Date: April 30, 2021  
To: All Proposers  
From: Megan Rogan, Purchasing Agent  
Subject: Addendum #2 to Bid# 121053 – HMA Pavement – County Projects

**CTH G (STH 92 to USH 18/151)**  
**Towns of Springdale and Verona**  
**Project No. 68234-2100**  
**CHIP Funded**

**PROPOSED TYPICAL SECTION**  
**CTH G**  
**BENCH AND WIDEN**  
**(STA. 0+38.5 - STA. 243+36)**

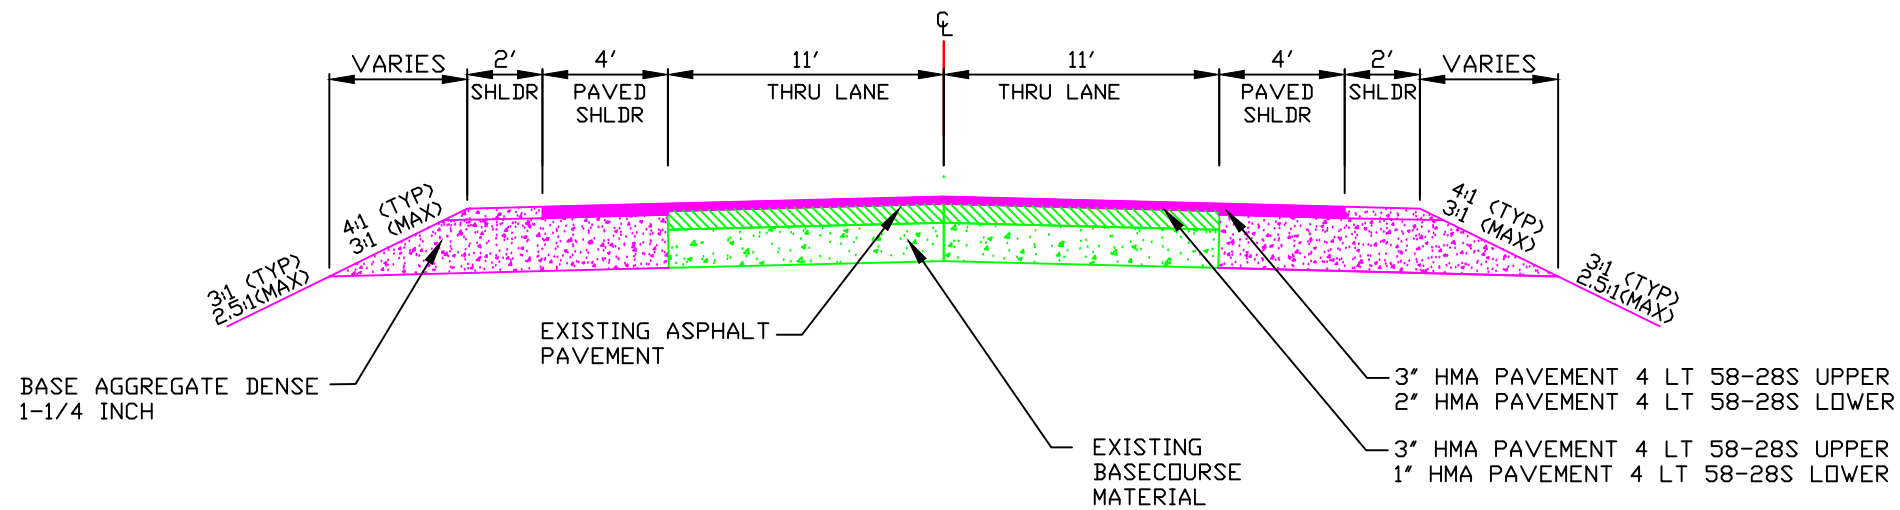
5. Will Dane County Sawcut prior to the removing asphalt surface item? In not is this required for the item? **No, sawing is not required.**
6. Can a typical section plan be provided for the different sections of roadway? **Yes, see page 6 of this addendum.**

7. Addendum 1 response to question 2 indicates removing asphaltic includes 3' shoulders (Assumed to be HMA due to the item), Response to question 4 states the 3LT mix is installed 4' wide for the 2" lower on this shoulders. Is Dane county widening an additional 1' after the removing asphaltic surface item is performed? **Yes, see typical.**
